ADDENDUM NO. 5

DATE: September 30, 2026
PROJECT: WWTP CSO 1 Improvements
OWNER: City of Elwood
ENGINEER: Whitaker Engineering

PROJECT: City of Elwood WWTP
CS01 Improvements
Elwood, Indiana 46036

1 TERTIARY BUILDING FIRST FLOOR PLAN - ELECTRICAL

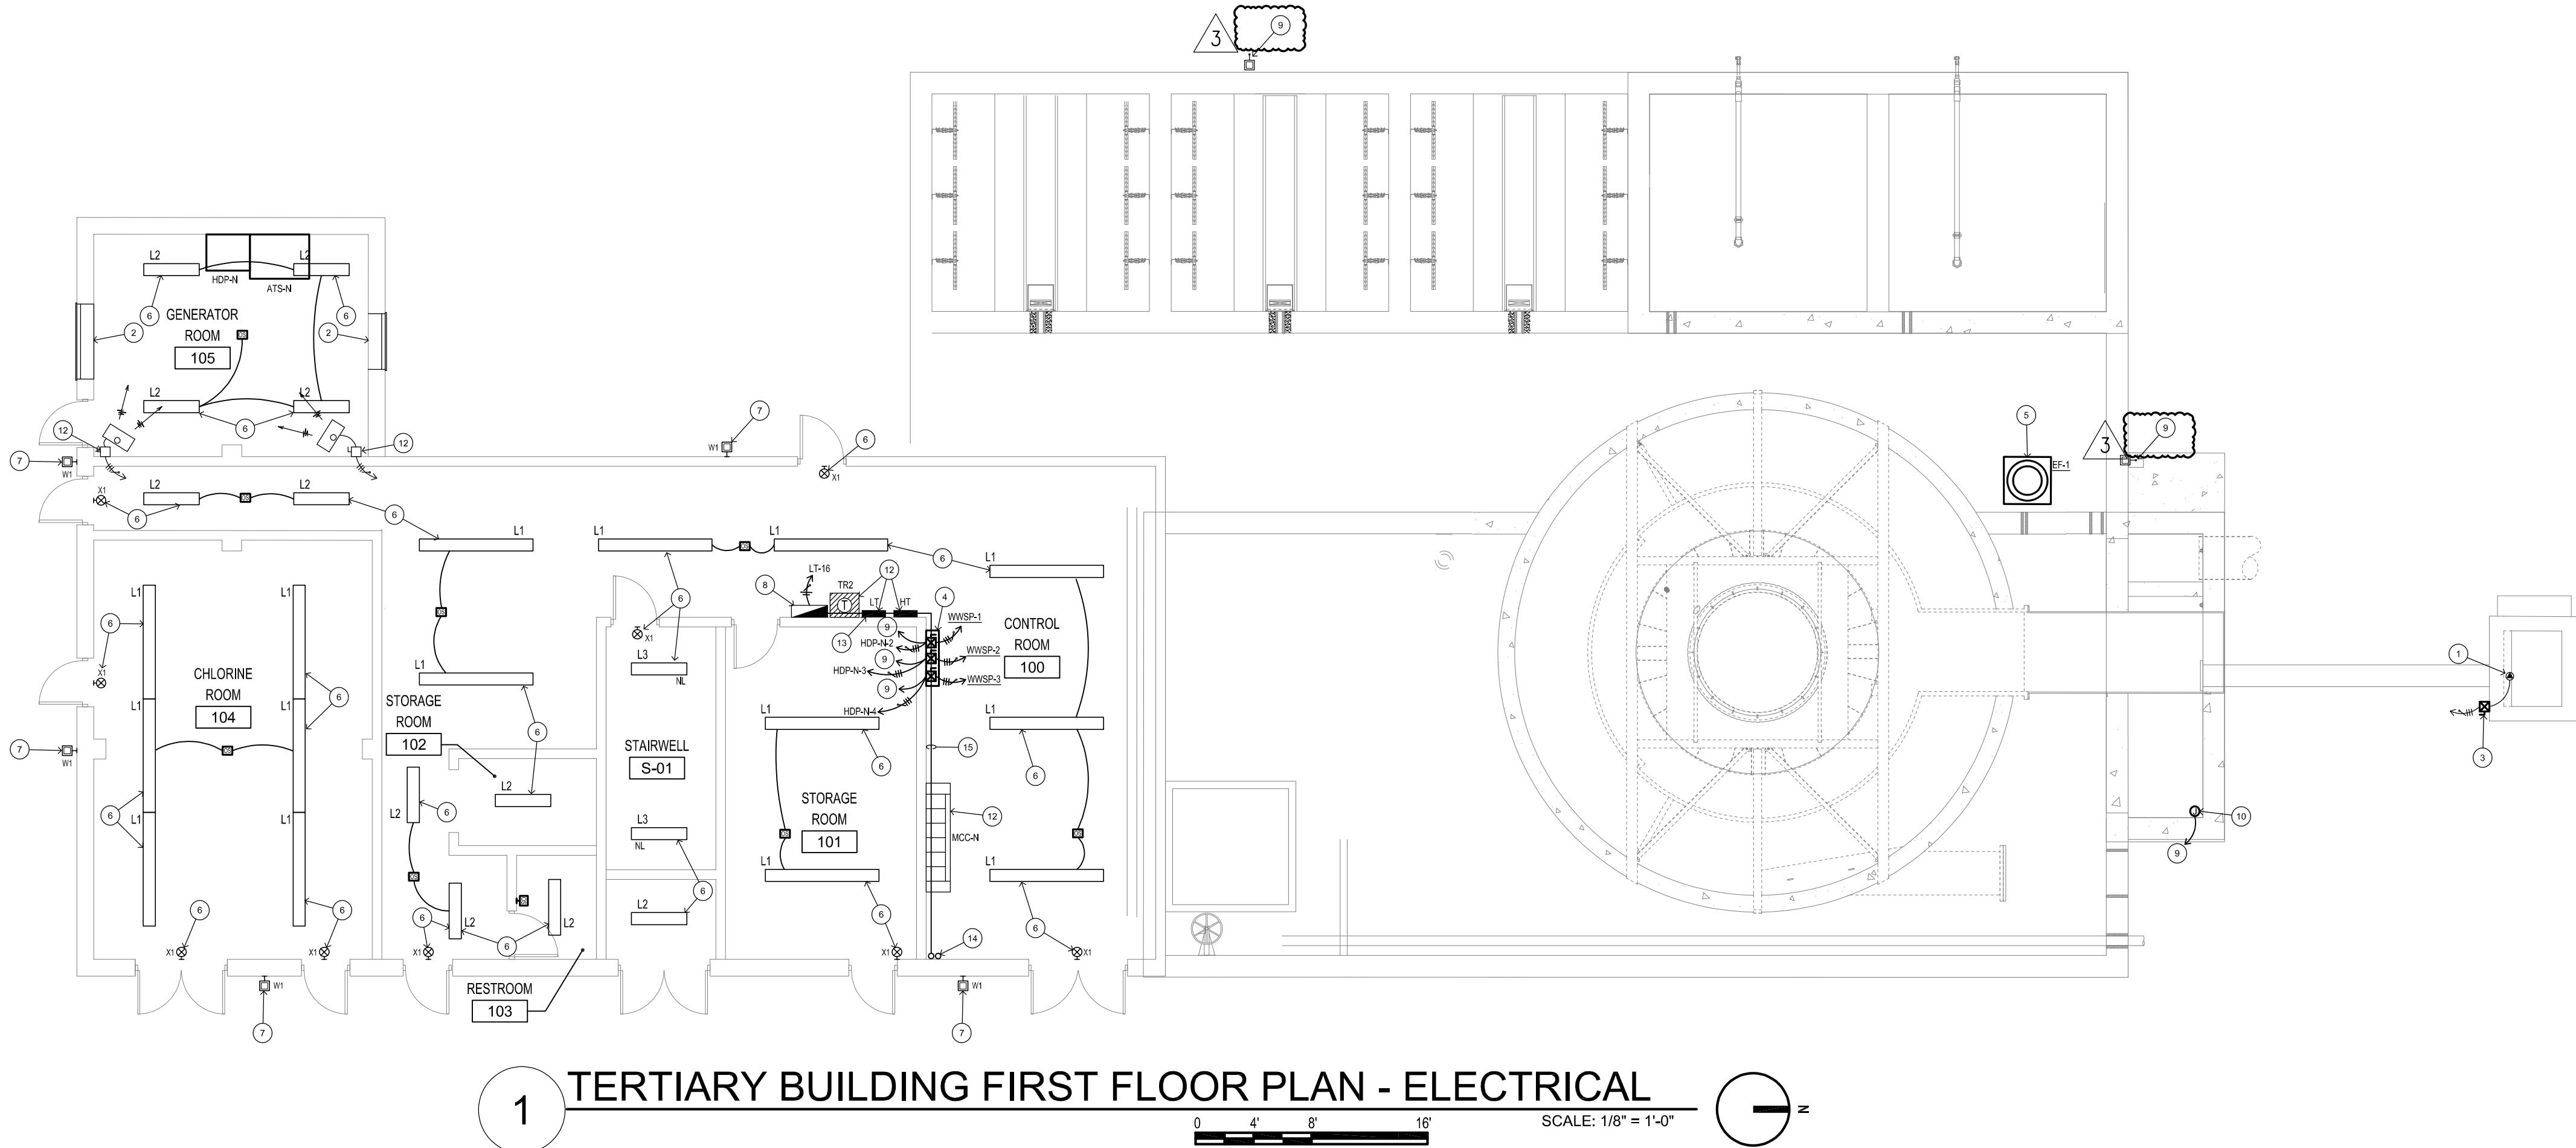
- i. E202 TERTIARY BUILDING FIRST FLOOR PLAN – ELECTRICAL
 - 1. See changes to sheet plan note #7.
 - 2. See change to sheet plan note #9.
- ii. E701 ONE-LINE DIAGRAM
 - 1. See changes to Existing One-Line Diagram.
 - 2. See changes to Revised One-Line Diagram.
 - 3. See addition of sheet plan note #15.
 - 4. See addition of 'Switching Order'.

- Response: See attached revised drawing E701.
- iv. Note 7 on E202 Says to Connect new light Fixture to Existing Branch Circuit and to see Details for Additional Info. The only info I see is showing a new Pole Base. These Lights are also not on the Fixture Schedule. Will these be New Pole Bases, Poles, and Fixtures? Or Just New Fixtures? Any Specs.

- Response: See attached revised drawing E202.
- v. Are there any Plans for the Changeover from Old to New Service at both Buildings? Will Generator Rental be Required to Keep Plant Running.

7. CONNECT NEW LIGHT FIXTURE TO EXISTING LIGHTING BRANCH CIRCUIT.
8. CSO PLC CONTROL PANEL. ALL TERMINATIONS IN PANEL SHALL BE BY ELECTRICAL CONTRACTOR.

9. EXISTING POLE MOUNTED LIGHT TO REMAIN.
10. DECHLORINATION CHAMBER/EFFLUENT CHAMBER ULTRASONIC LEVEL SENSOR.
11. NOT USED.
12. EXISTING ELECTRICAL EQUIPMENT TO REMAIN.

ELECTRICAL RISER

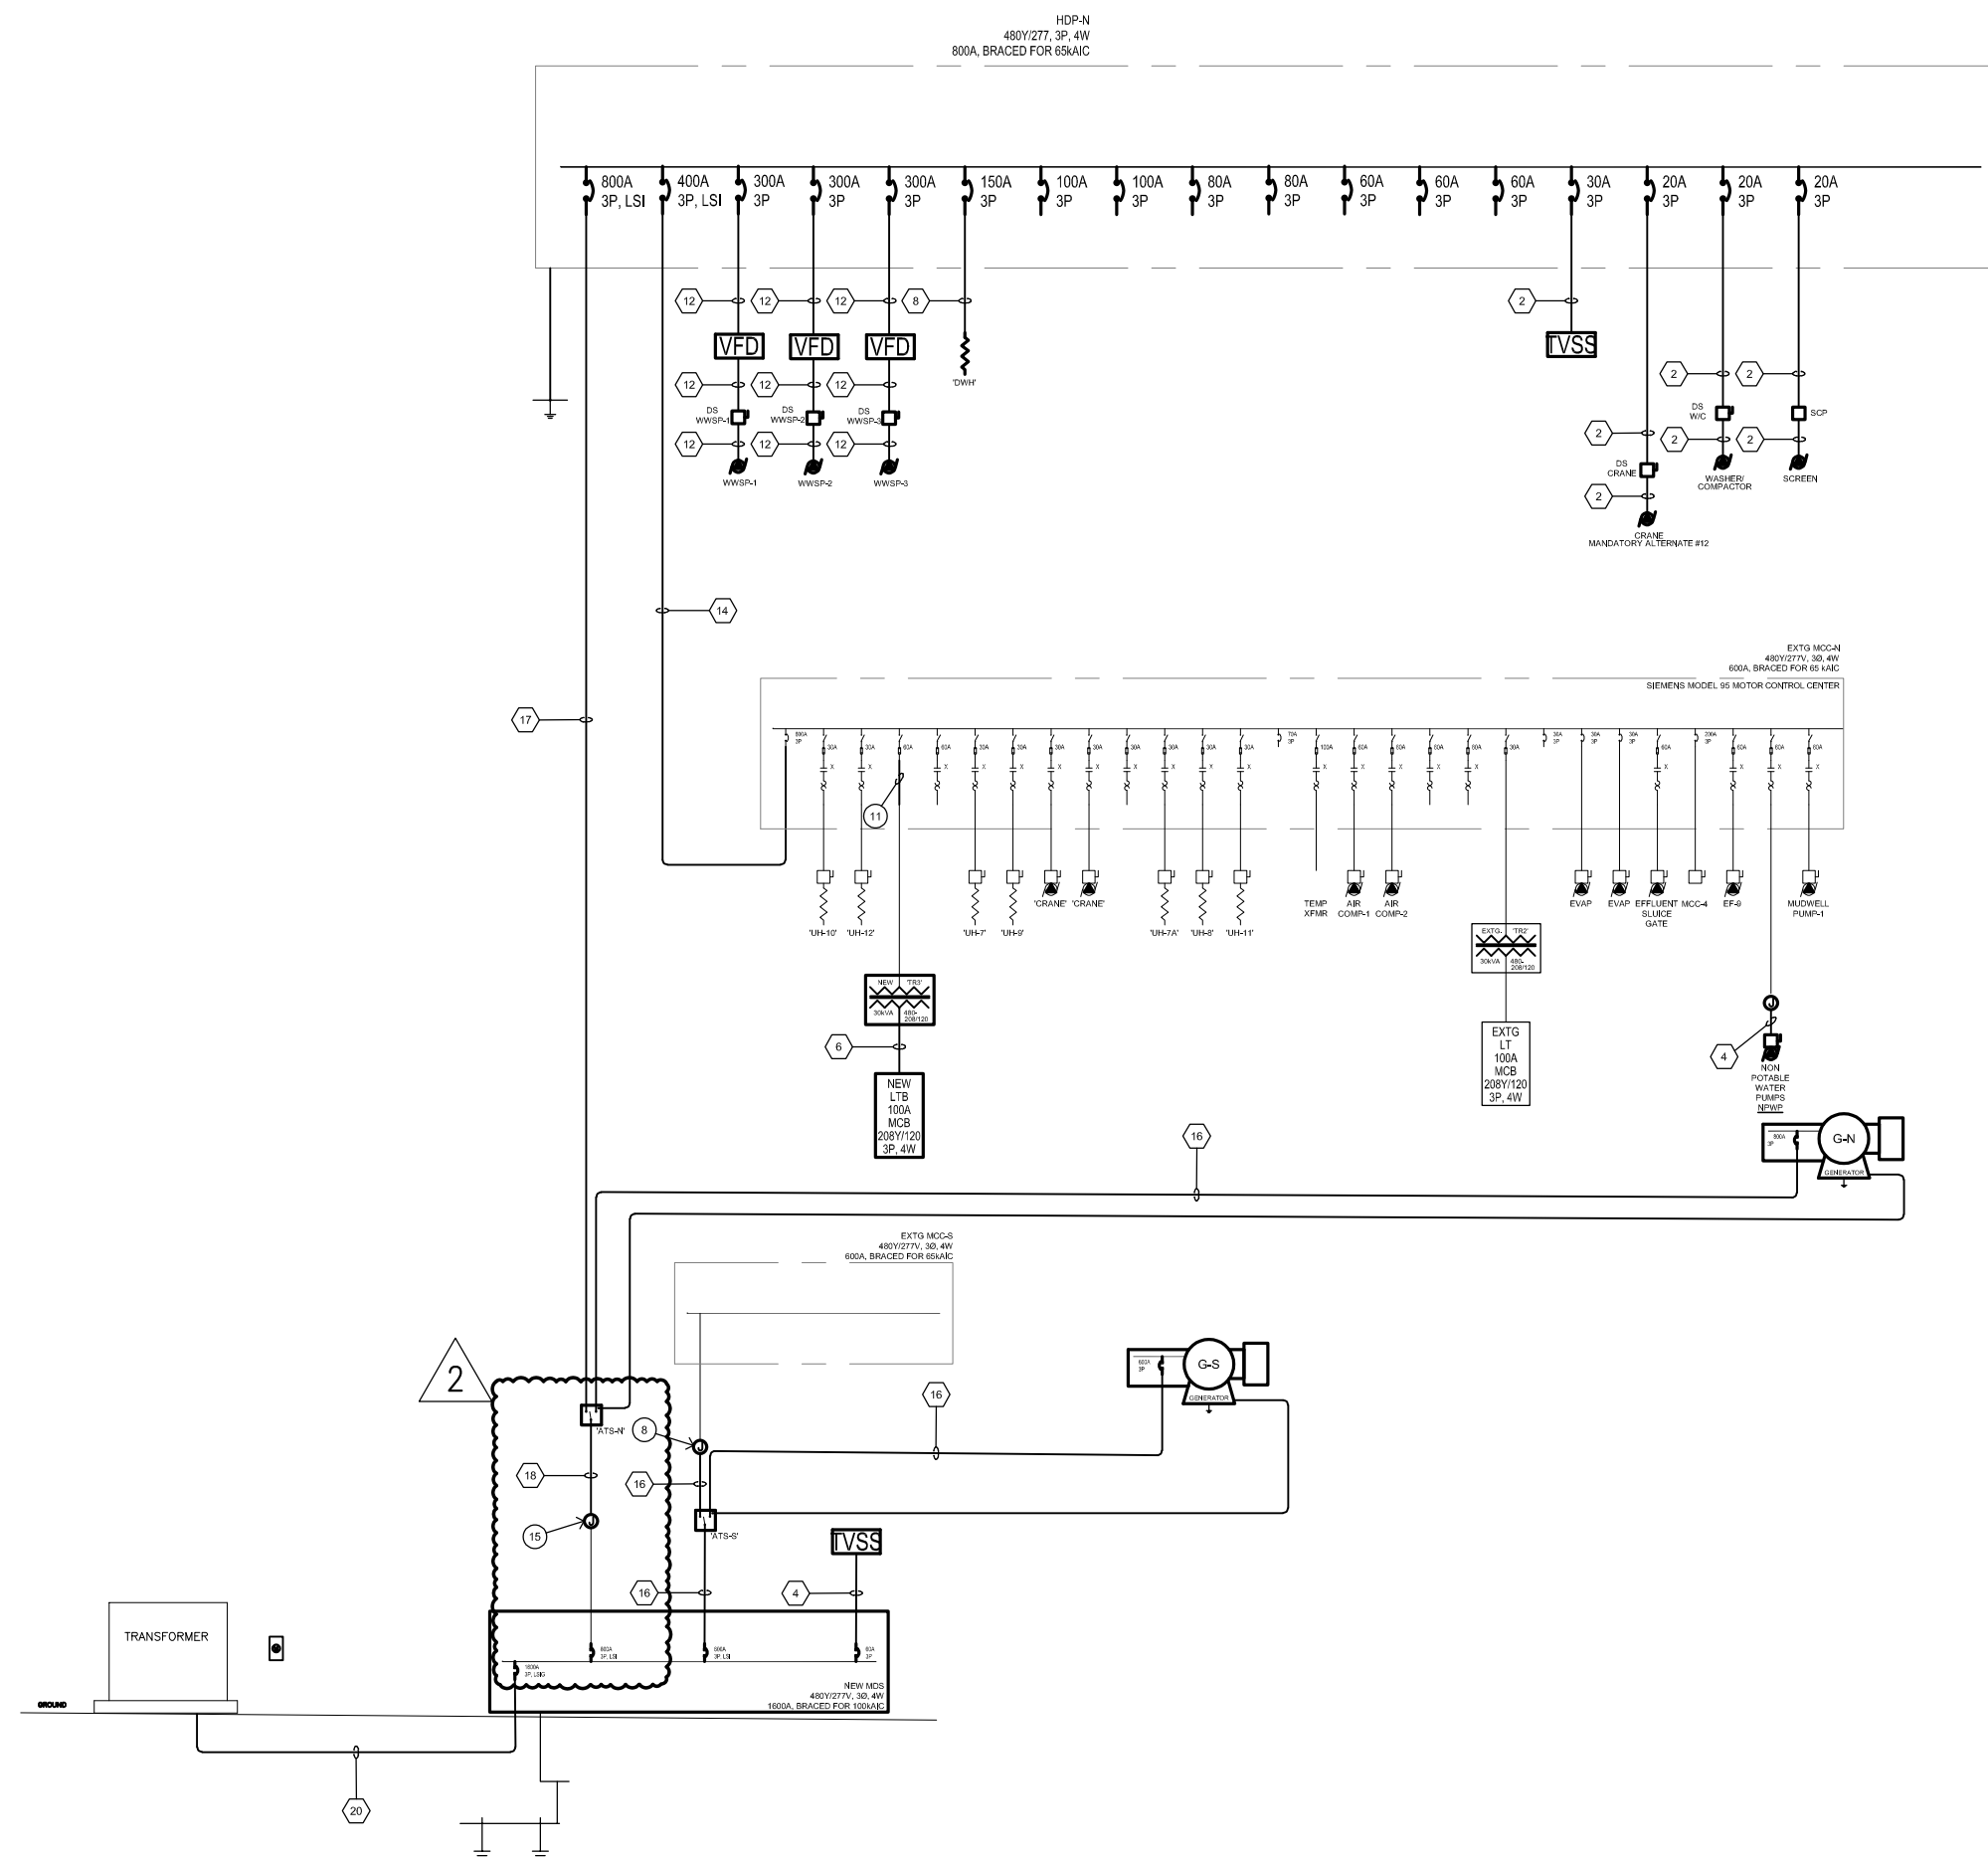
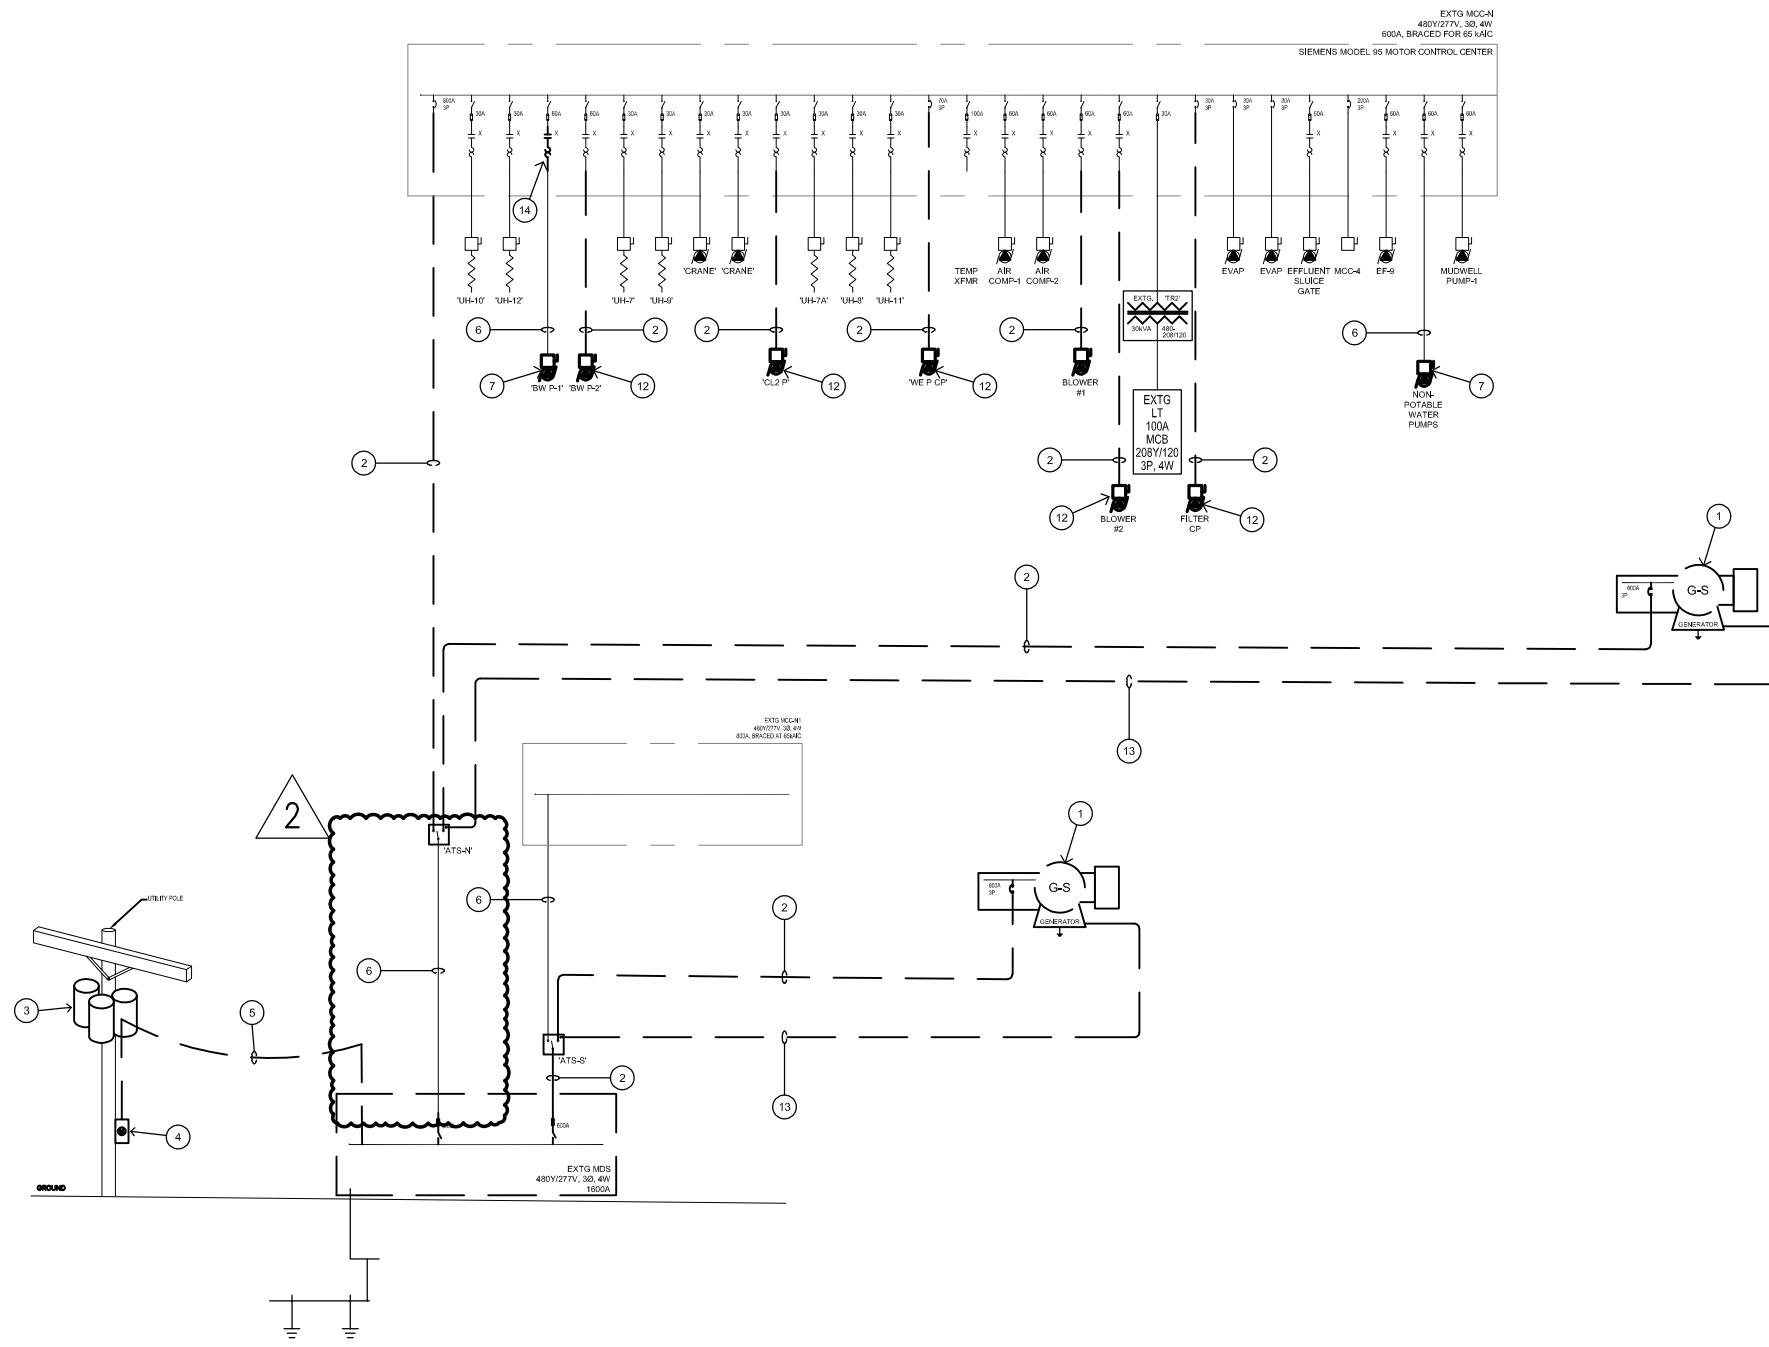
- iii. New 800A Circuit to ATS-N in Tertiary Building from Pump Building. I do not see any Details on this Circuit, the New ATS and Old ATS are in Different Locations in the Tertiary Building. Will this be a New Underground Duct Bank

- vi. Are there any Plans for the Removal of Old MDS and ATS in the Pump Building? Cabinets will not fit through Opening. Disassembly will extend Downtime to Plant?
 - Response: See attached revised drawing E-701. See 'Switching Order'.
- vii. Can there be an Option to Disconnect and abandon the old lights in place in the Pipe Gallery? Removal will be Difficult and Expensive, especially if Pipe is not Removed per Deduct. New Lights Shown mounted at 7'-6" AFF.
 - Response: This is acceptable. Existing lights in the Pipe Gallery shall be disconnected and abandoned in place. Removal of the existing light fixtures in the Pipe Gallery is not required and should not be included in the Contractor's bid.

- Response: See attached revised drawing E701. See ‘Switching Order’.

SWITCHING ORDER

- Installation of new pad mount utility transformer
a. Pump Building
i. EC shall coordinate the installation of new pad mount transformer with AEP.
ii. EC shall install new generator G-S and provide temporary connection to Old ATS-S.
iii. EC shall demolish existing generator G-S and all associated equipment inside the existing generator room.
iv. EC shall install new secondary service lateral from location of new pad mount transformer to location of new MDS.

v. EC shall install new ATS-S including all feeder circuits to generator GF-S, to new MDS, and to location of Old MDS.
vi. EC shall install feeder circuit from new generator G-S to new ATS-S.
vii. Disconnect existing MDS and set to side for future demolition after system has been re-energized.
viii. Splice existing feeder circuits previously serving MCC-N1 and Old ATS-S to new feeder circuits from new MDS.
ix. Install junction box over splices.

x. EC shall demolish Old ATS-S.
xi. EC shall demolish Old MDS.
b. Tertiary Building
i. EC shall demolish existing generator G-N and all associated equipment inside the existing generator room.
ii. EC shall install new HDP-N and new ATS-N.
iii. EC shall install feeder circuits, through the interior of the Tertiary Building, between the new HDP-N/ATS-N and Old ATS-N.
iv. EC shall demolish existing ATS-N.

v. EC shall splice existing feeder circuit from Old MDS to new HDP-N.
vi. EC shall splice existing feeder circuit from MCC-S to new ATS-N.
vii. EC shall install junction box over splices.

2. Energize new pad mount transformer.
